Bristol Tree Forum Submission

Hengrove Leisure Park Hengrove Way Bristol BS14 0HR - 21/00531/P | Outline planning application for demolition and residential-led redevelopment

Figure 4: Trees identified for thinning and removal around the play park

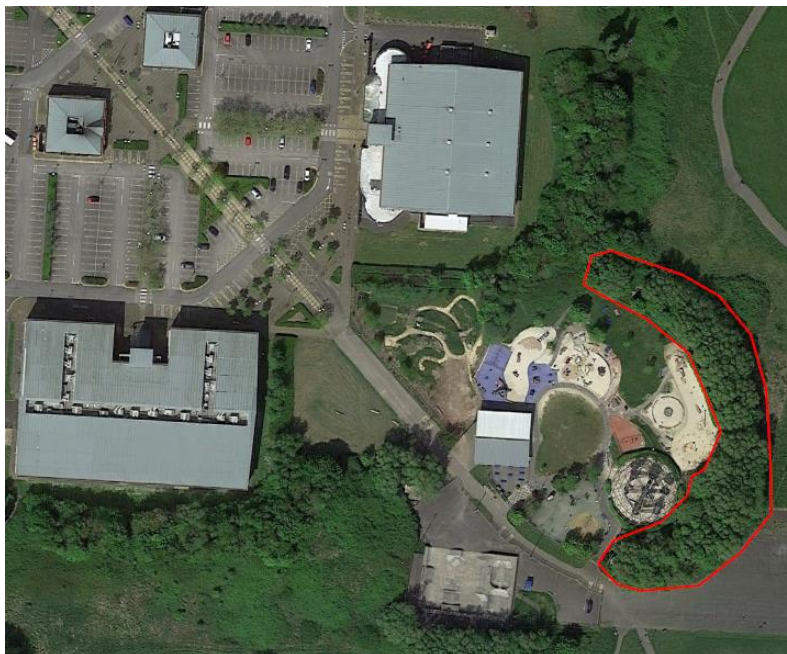
substantial number of these will be from around the play park to the south-east of the leisure park. (Some of these trees will be thinned but we estimate that about 75% of them will be lost.) The fact that these trees were only planted some 12 years ago to create a screen around the play area will not save them².

Taken as a whole, these three developments will result in the removal of over 1,500 well-established, mature and semi-mature trees. We are told that these lost trees will, in due course, be replaced. How and when this will happen remains uncertain, however, and in any event, it will take at least another 20-30 years before any new trees can replace all the benefits of the existing trees. In short, we are being asked to accept the replacement of what already exists with a promise of future trees that may never be realised.
